To: Loney, Adam[aloney@craworld.com]; Patterson, Leslie[patterson.leslie@epa.gov]
Cc: Brett.Fishwild@CH2M.com[Brett.Fishwild@CH2M.com]
From: Marshall, Laura
Sent: Thur 3/14/2013 4:33:45 PM
Subject: RE: SDDL Phase 1A outline comments

From: Patterson, Leslie [<mailto:patterson.leslie@epa.gov>]
Sent: Tuesday, March 12, 2013 4:13 PM
To: Loney, Adam
Cc: Brett Fishwild; Bryan Heath; James Campbell; Ken Brown; Laura Marshall; Paul Jack; Chan, Valerie; Quigley, Steve
Subject: SDDL Phase 1A outline comments

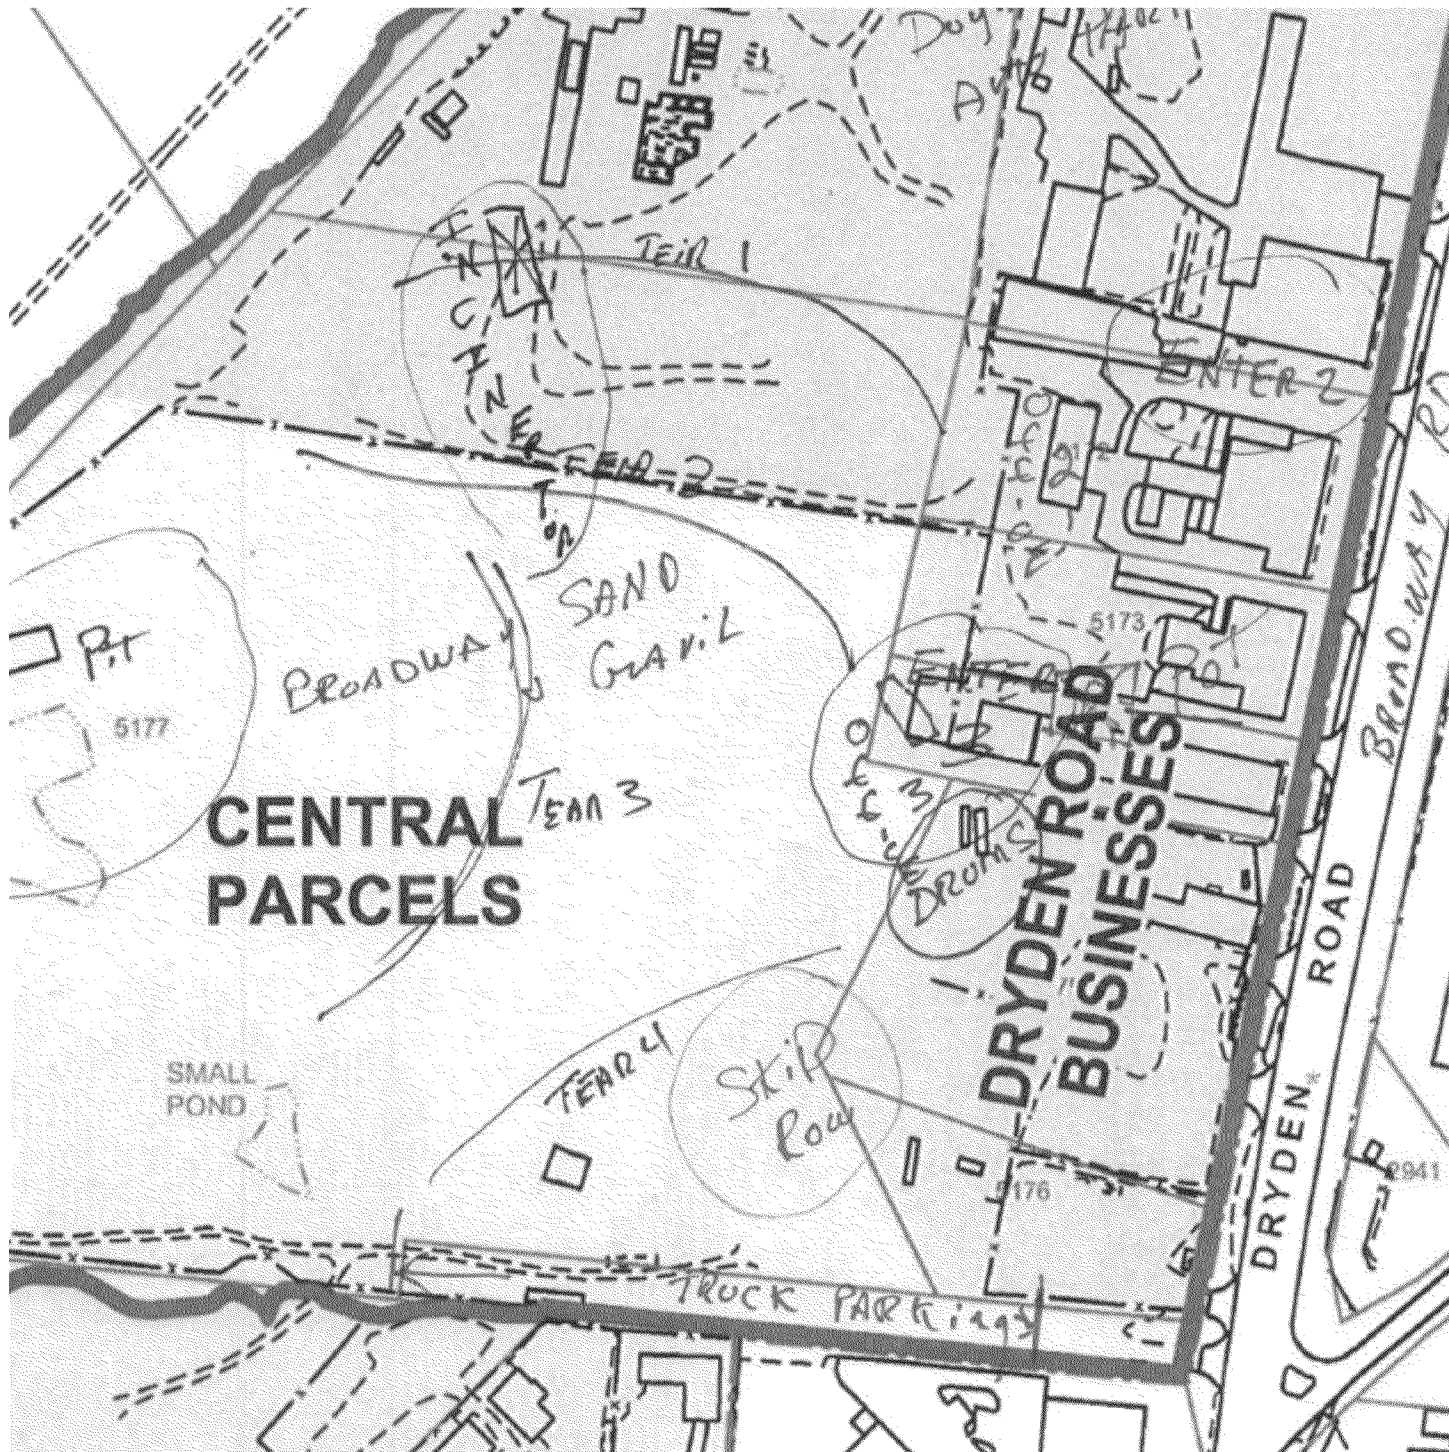
Sure, here's the portion of the Grillot deposition Exhibit 2 that shows drums south of the Entrance 3 office. The transcription of the deposition talks about drums dumped "behind" entrance 3 though, so where that might have happened in relation to the office is a bit unclear. The area of concern would be the area around the office down to the area marked "drums".
